TO: M. JAWORSKI, S. GERHARDT

FROM: M.L. REINKE

SUBJECT: MODIFICATION OF HEAT FLUX REQUIREMENTS FOR OBD R3 & R4 TILES

Figure 1: Equilibrium which drives OBD-R4 requirement for CASE#1 and the heat flux profile modeling (right). The green-dashed line is the time-averaged heat flux, assuming fast sweeping.

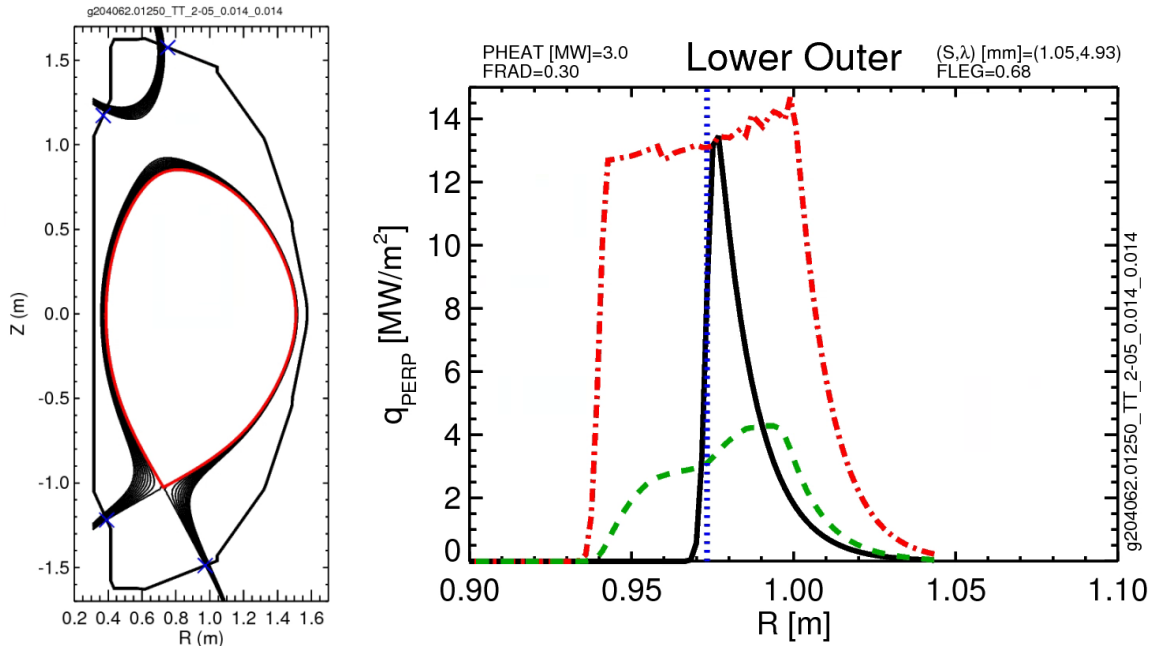
Examining PFCR-MEMO-008 [2] in more detail reveals the origin of the SRD requirement for OBD-R4 (CASE#1 through CASE#3). These are lower single null L-mode cases which create high heat flux due to weak flux expansion, despite limited input power. The most challenging requirement is CASE#1 which requests OBD-R4 sustain 4.3 MW/m^2 for 2 seconds. This is from the TT_2-05b case in Table 4.2.4 in [2], which is an L-mode plasma with 3 MW of input power.

Assuming 30% radiation and 70% going to the outer divertor, this is a total of 1.47 MW of power. The area of the OBD-R4 region is computed from a conical surface from (R,Z)=(96.65,149 cm) to (107.96,144.75), leading to a surface area of 0.773 m^2 . Note that adding up the x96 over and x96 under tile front surface

areas from the prior NSTX/NSTX-U beveled design estimate gives 0.666 m^2 . Neither of these accounts for tile gaps. If 4.3 MW/m^2 is assumed to be uniformly deposited on the swept conical R4 surface, then the total power deposited is 3.32 MW, over estimating the power input by roughly a factor of two. This is consistent with inspection of Figure 1, as the heat flux of 4.3 MW/m^2 describes the 'peak' which is not evenly distributed over the 11-12 cm length of the R4 surface. Adding an 'Extent' of 11 cm to Table 4.4-3 in [1] for CASE#1, CASE#2 and CASE#3 would improve agreement (Recommendation A).

- A. Adjust the OBD R4/5 heat flux requirement for CASE #1, #2 and #3 in Table 4.4-3 of [1] to add an Extent of 11 cm. This will have the effect of reducing the net energy input into the tile rows, bringing it more in line with the estimate from power balance.
- B. Remove the OBD R4/5 CASE #4 requirement in Table 4.4-3 of [1]. Scrutiny of scenarios shows driving scenarios will not place the strike point on R4.
- C. Adjust the OBD R3 heat flux requirement for CASE #1 in Table 4.4-2 of [1] to add an Extent of 11 cm. This will have the effect of reducing the net energy input into the tile row, bringing it more in line with the estimate from power balance.

Figure 2: Equilibrium which drives OBD-R3 requirement for CASE#1 and the heat flux profile modeling (right). The green-dashed line is the time-averaged heat flux, assuming fast sweeping.

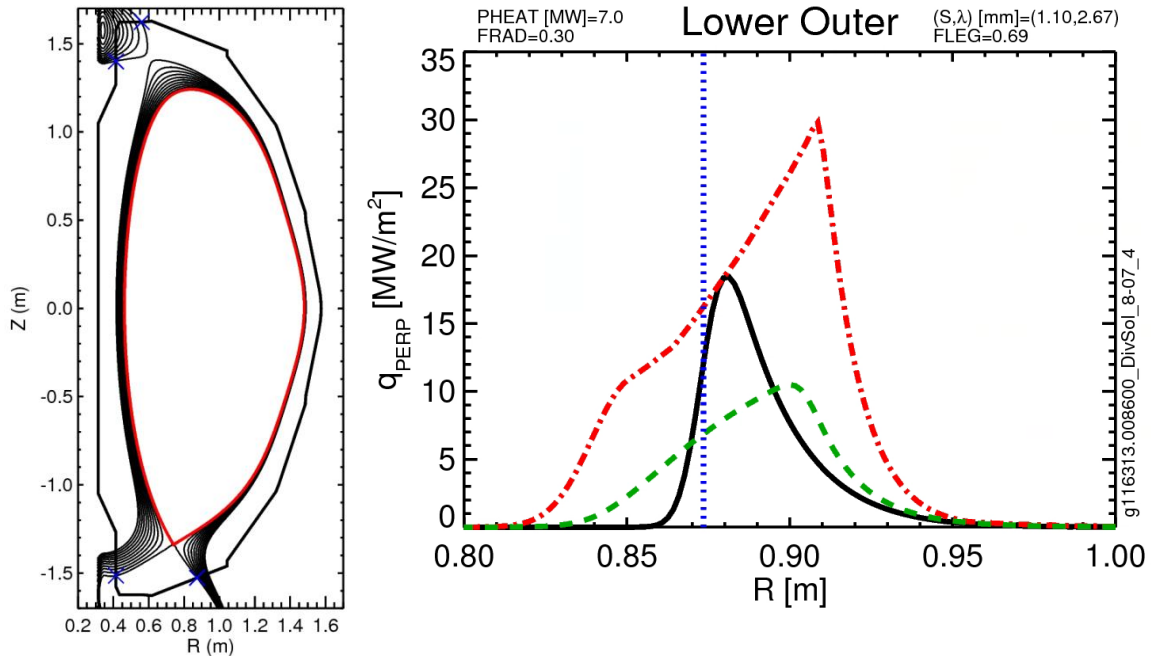
Examining [2] for what drives the SRD requirement for OBD-R4, CASE#1, the use is much different than R4. As outlined in Section 7, the R3 tile is meant to support low-triangularity H-mode research and as such has much higher input power than for OBD-R4. In fact, many DivSOL and PED requests have heat flux

that exceed CASE#1, but are declared to be to challenging without additional radiative exhaust or further confirmation of the heat flux width scaling. This means the physics program would benefit from an OBD-R3 which can exceed the given requirements.

Following the same analysis as above, the swept surface area of the R3 tiles is computed from $(R,Z)=(84.9,153.7)$ to $(96.4, 149.1)$ cm results in an area of 0.705 m^2 . The CASE#1 has 7 MW of input power, resulting in 3.43 MW of power going to the outer divertor. The requirement for 10.5 MW/m^2 applied uniformly over the tile would lead to 7.4 MW of power going into the PFC. Once again this is approximately twice the power that is being delivered and adding an 'Extent' to the heat flux requirement of 11 cm would bring the power delivered closer in line to the underlying scenario and bring the heat flux profile closer to matching what is shown in Figure 2 (Recommendation C).
